Amendments/Additional Information

Listed building and planning consent for conversion of outbuildings to form 2no.holiday cottages at outbuildings Lowdale Hall Sleights

Dwg. no. 2016/04/10

Dwg. no. 2016/04/11

Cross section PROPOSED

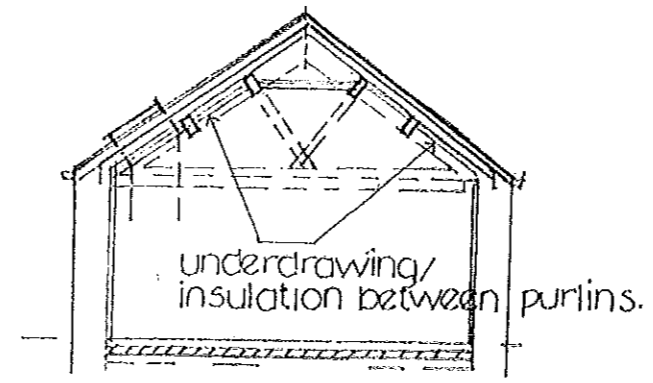
- 1.The window details have been amended as suggested.
- 2.There appears to be some misunderstanding regarding the ceiling treatment. The section drawing is intended to indicate that underdrawing /insulation will be between the purlins as preferred. I confirm however that this will be the case.
- 3.The stone flags have been retained for re-use and as suggested my client will agree the details of the re-use with you/your officers on site .

elevation to courtyard PROPOSED

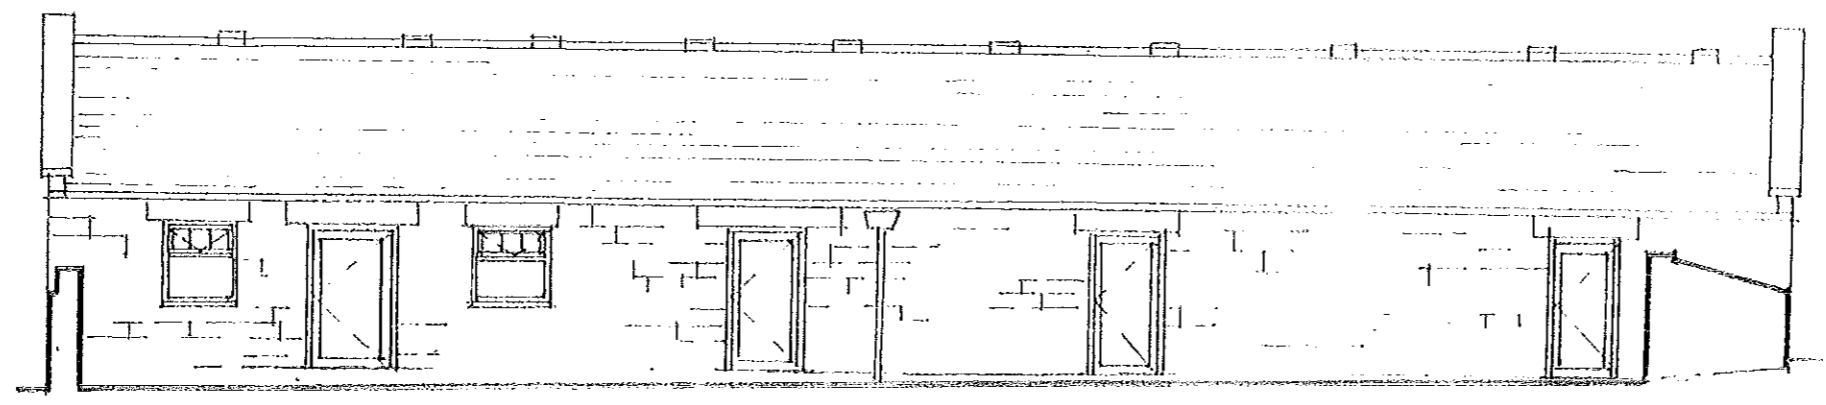
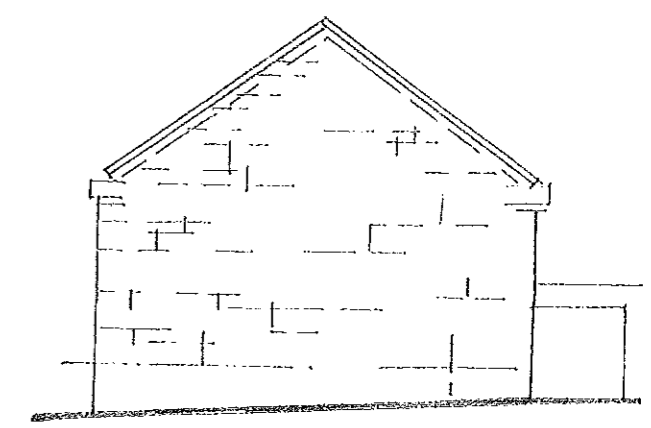
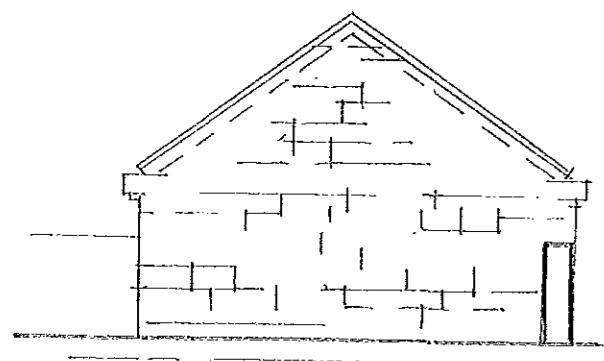
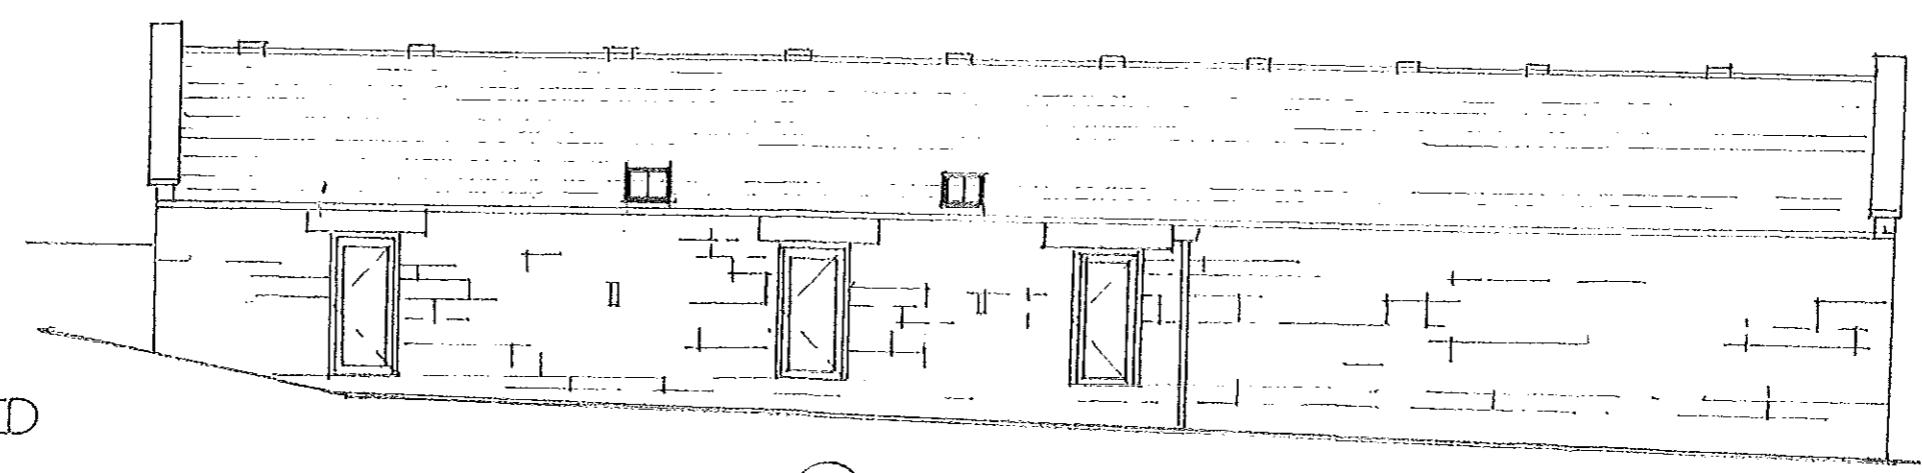
I have spoken to my client and it is clear that the scheme is not viable if only a single unit is provided therefore the layout suggested by the conservation officer is not viable. It is felt that the latest proposals address your main concerns. In relation to the roof windows in particular there are only 2 provided and these are of minimum size to meet Building Regulation requirements. Furthermore the simple treatment of existing openings with timber frame glazed panels is in line with your general guidance (please note that these will have to be openable to meet building regulations.) However we have considered the other points raised in your letter and clarify/address those issues as follows:-
